# SPARTAN MOTORS CHASSIS, INC.

CSB09-170-005

## CAMPAIGN SERVICE BULLETIN

- SUBJECT:** Engine – FEAD Bracket/Fan Clutch
- APPLIES TO:** Certain Spartan Motors Chassis, Inc. Firetuck Cab/Chassis. Equipped with a CAT® C-9 engine and having a VDM (Vehicle Date of Manufacture) August 18, 2008 through June 11, 2009.
- CONDITION:** FEAD Bracket or Fan Clutch failure
- CORRECTION:** Replace FEAD Bracket and Fan Clutch

**FIG. 2-1**

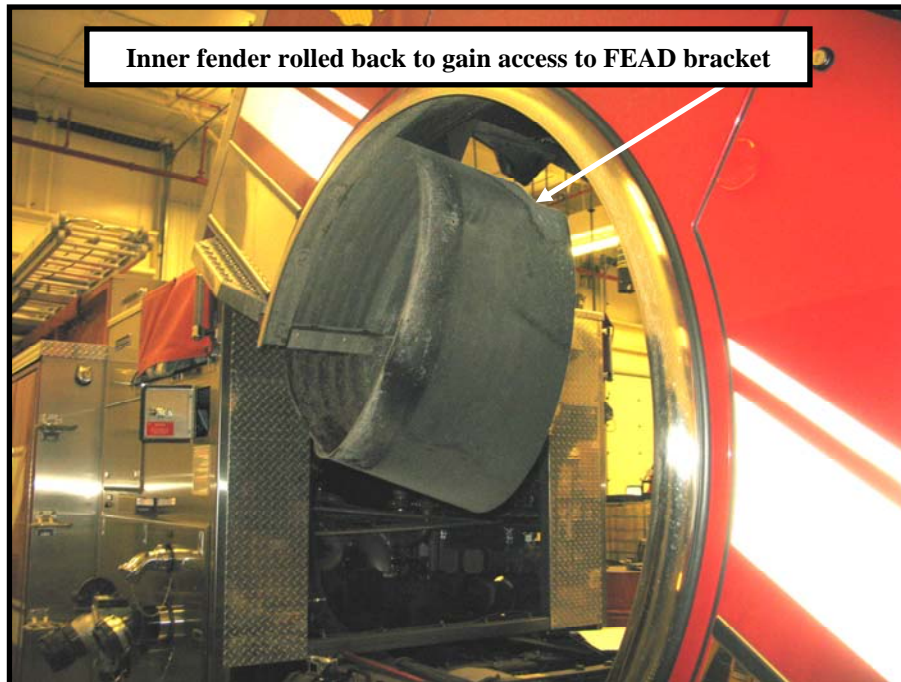
2. Remove new FEAD bracket from kit. If bracket is not painted you should paint entire bracket to protect from corrosion.
3. Tilt cab up following instructions on placard.
4. Disconnect power source from battery.
5. Refer to FIG. 2-1. Remove inner fender liner from passenger side only. Retain hardware for reuse.
6. Remove fan blade, retain fan for reuse. Properly discard washers and nuts.
7. Refer to FIG. 3-1. Slide fan blade forward into shroud out of way.
8. Relieve tension and remove serpentine belt. Inspect belt and replace if needed, otherwise retain belt for reuse. Belt part number is 10PK2680.

25. Refer to FIG. 2-1. Re-install inner fender liner to passenger side using retained hardware. Secure as needed.

**OLD FEAD BRACKET**  
**FIG. 4-1**

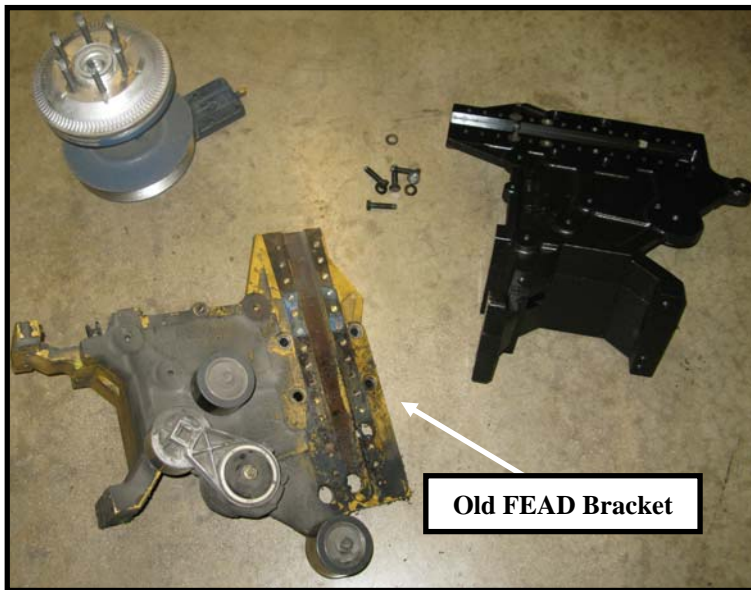
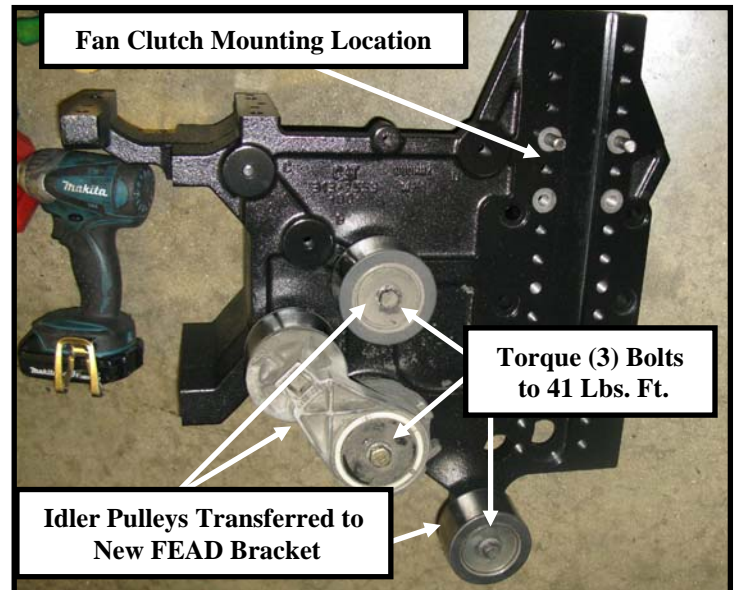
16. Refer to FIG. 4-1, 4-2. Transfer the idler pulleys, belt tensioner, and hardware onto new bracket. Ensure the rubber O-ring is on the bolts for the pulleys before reinstalling to new bracket. Torque three bolts to 41 lbs. ft. Properly discard FEAD bracket.

**FAN CLUTCH**  
**FIG. 5-1**

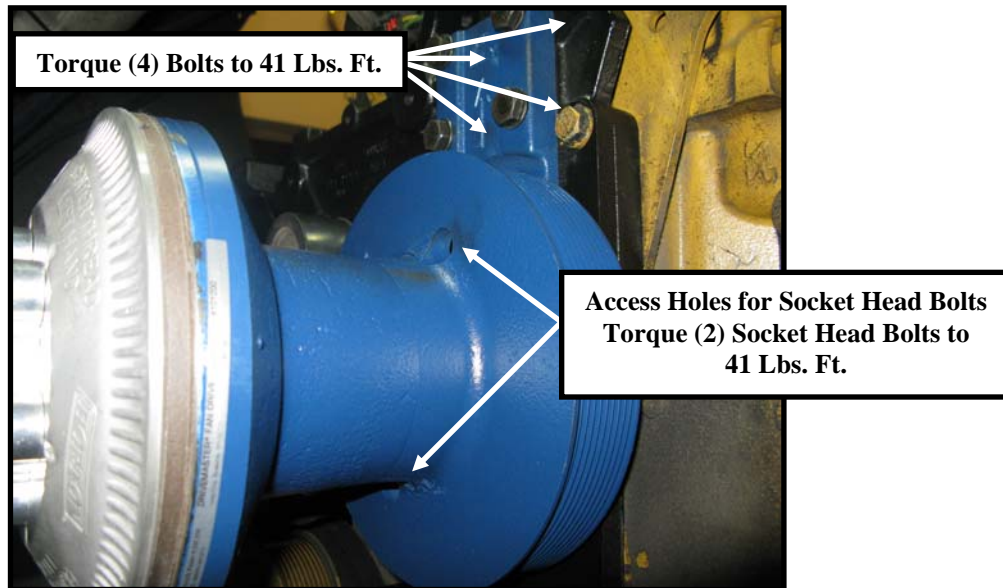
17. Refer to FIG. 6-1. Install new FEAD bracket using new hardware. The small bolt & washer on side behind alternator mount torque to 24 lbs. ft. the other four bolts & washers torque to 41 lbs. ft.
18. Refer to FIG. 5-1. Install new fan clutch using two socket cap bolts and four bolts/washers from kit. Torque to 41 lbs. ft.
19. Re-install A/C compressor and bracket using retain hardware. Torque to 21 lbs. ft.
20. Re-install alternator with retained hardware. Torque to 41 lbs. ft.
21. Re-connect power and ground cables to alternator.
22. Re-install 2 loop clamps around battery cables using retained hardware. Secure as needed.
23. Refer to FIG. 5-2. Re-install serpentine belt. Align in grooves of all pulleys.

**FAN CLUTCH & FAN MOUNTING**  
**FIG. 6-1**

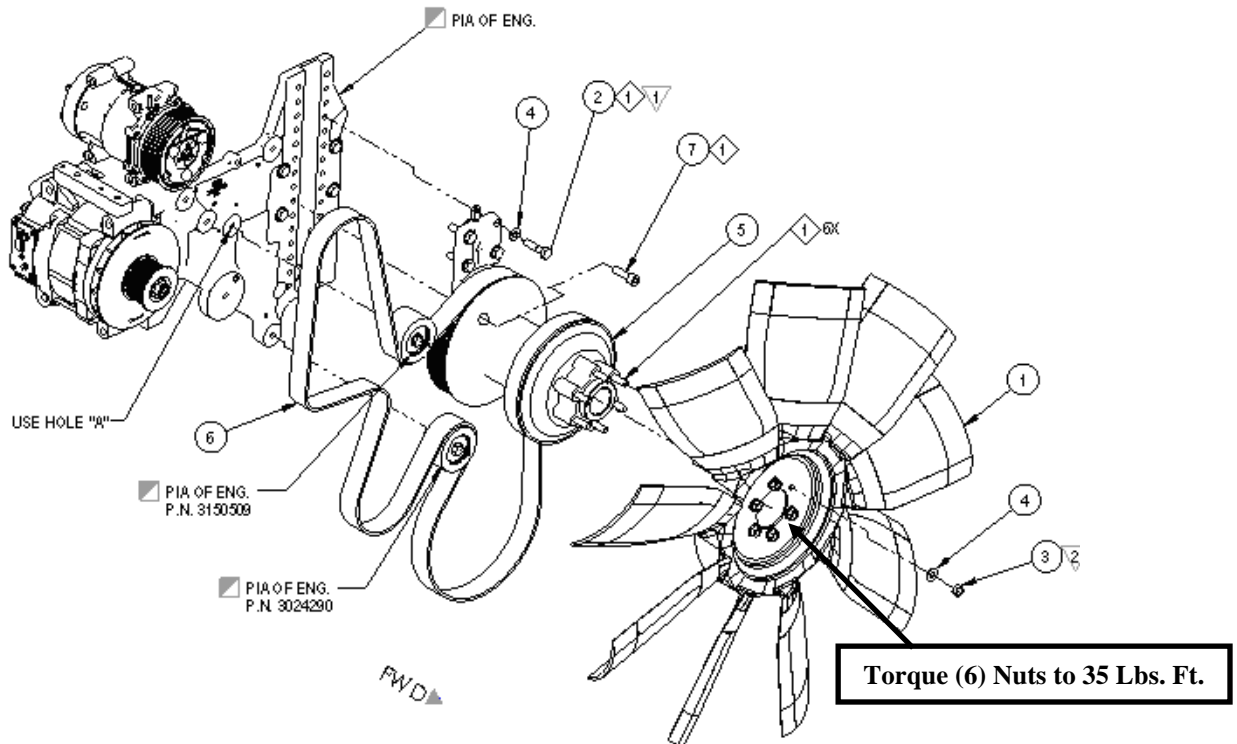
24. Refer to FIG. 6-1. Re-install fan blade using (6) nuts and washers. Torque nuts to 35 lbs. ft.
